Informal Document No. **GRSP-35-14**
(35th GRSP, 3-7 May 2004,
agenda item A.3.)

PROPOSAL FOR A GLOBAL TECHNICAL REGULATION ON
DOOR LOCKS AND DOOR RETENTION COMPONENTS

REVISION 1

Transmitted by the Expert from the United States of America

Figure 2 – Door Latch – **Static Load Test** Fixture (**Lateral Load**)

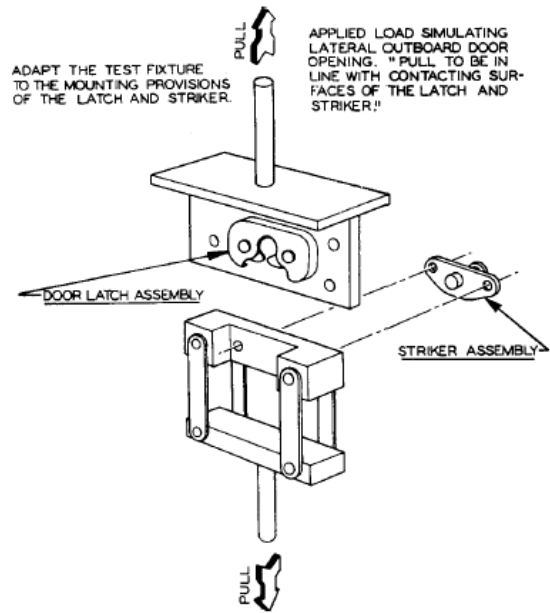
Figure 2 – Door Latch – **Tensile Testing** Fixture (**Transversal Load**)

[OICA & USA]

Figure 3 - Door Latch – Tensile Testing Fixture (Vertical Load)
[USA – entire figure 3]

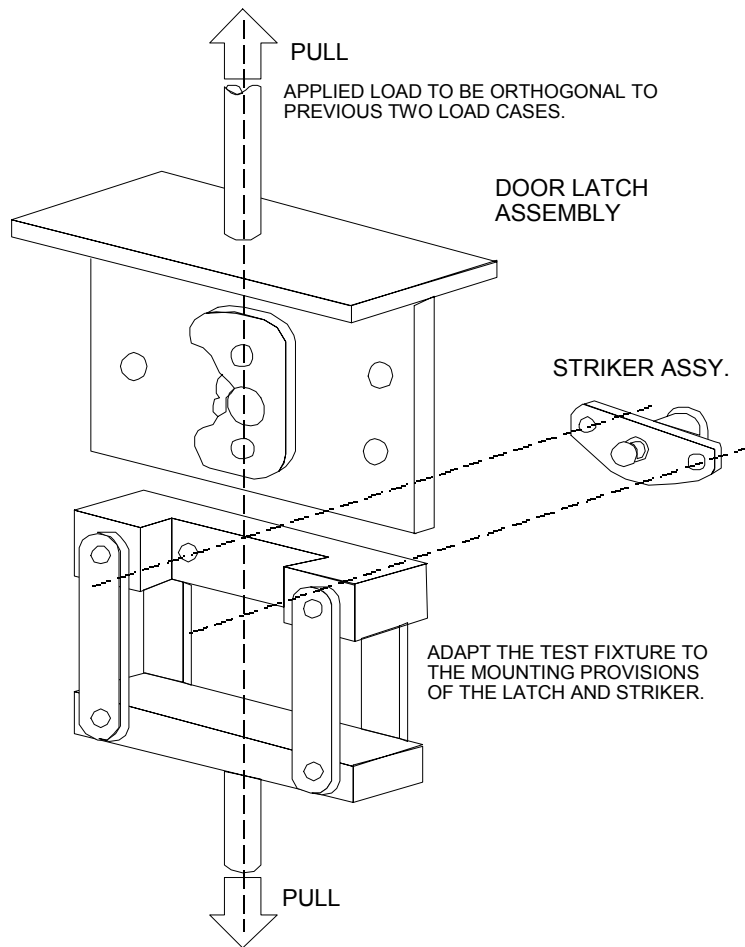
[USA – add Load Test Three to address vertical testing per the regulation]

Figure 2 – Static load test directions for back doors

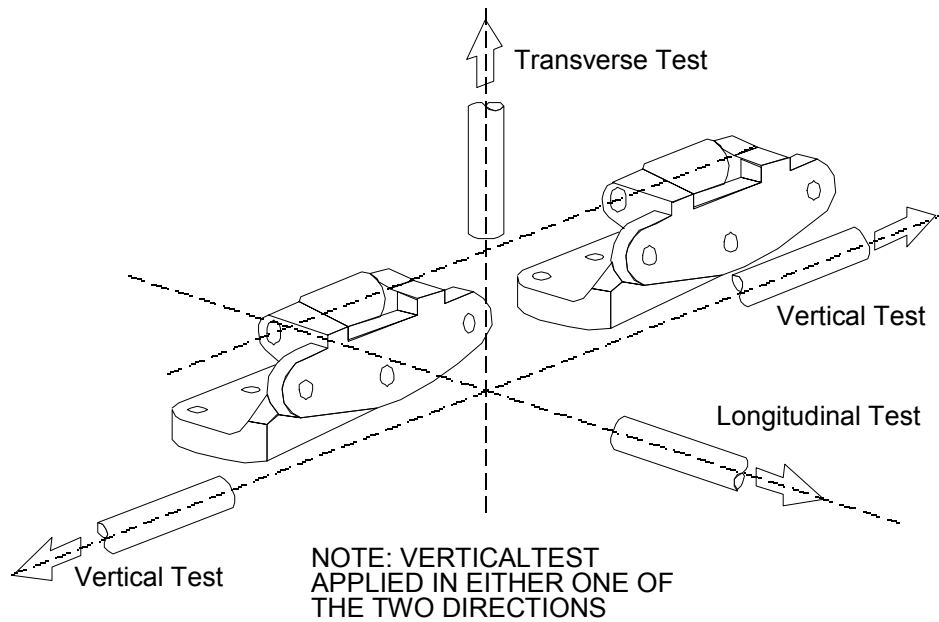
[USA – Add Figure 2]
